**BEFORE THE PUBLIC UTILITIES COMMISSION
OF THE STATE OF CALIFORNIA**

Rulemaking 11-10-023

**CALIFORNIA INDEPENDENT SYSTEM OPERATOR CORPORATION
COMMENTS ON THE PROPOSED
FLEXIBLE CAPACITY PROCUREMENT FRAMEWORK**

Figure 1: System-Wide ISO Forecasted Flexible Capacity Category Requirements, 2016

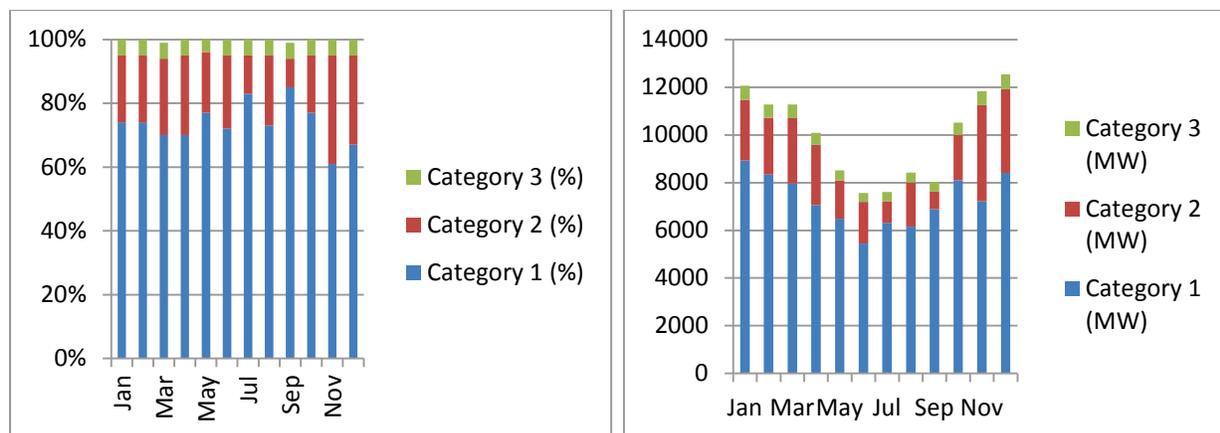
Additionally, the ISO believes that fixed percentage would lead to over procurement of flexible capacity in some months and under procurement in other months. For example, using the data provided in the previous resource adequacy cycle, the ISO calculated the needs for flexible capacity in each of the identified categories. The results for 2016 are shown below in Figure 1.

As these graphs show, category 1 flexible capacity can vary from between 61%-85%, which translates to a range of about 5,400 MW and 8,900 MW. Using fixed percentages could lead to excess procurement of category 1 flexible capacity resources in many months. Figure 2 further illustrates this.

category 1 flexible capacity is above the fixed percentage would lead to an increased possibility for backstop procurement. Based on this data, the use of monthly flexible capacity needs would also better serve to avoid over procurement or backstop for under procurement than a fixed yearly percentage for each flexible capacity category. The ISO encourages the Energy Division to allow the category percentages to be determined by the flexible capacity requirement assessment.

Figure 2

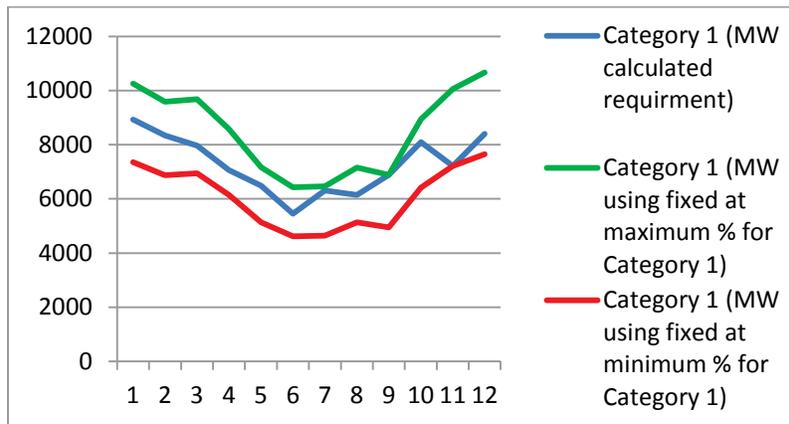
Figure 2 shows the difference in category 1 flexible capacity procurement assuming that percentages are fixed at the highest percentage (the green line), lowest percentage (the red line), and the percentage identified by the flexible capacity requirements assessment. Fixing the percentages does not flatten the quantity of flexible capacity that would be procured.

Figure 2 also shows that fixing the flexible capacity percentage will increase the probability of suboptimal procurement (i.e. either over-procurement or under-procurement) of category 1 flexible capacity procurement relative to the identified need. Months where the required amount of category 1 flexible capacity is below the fixed percentage shows an over-procurement, while months where the required amount of
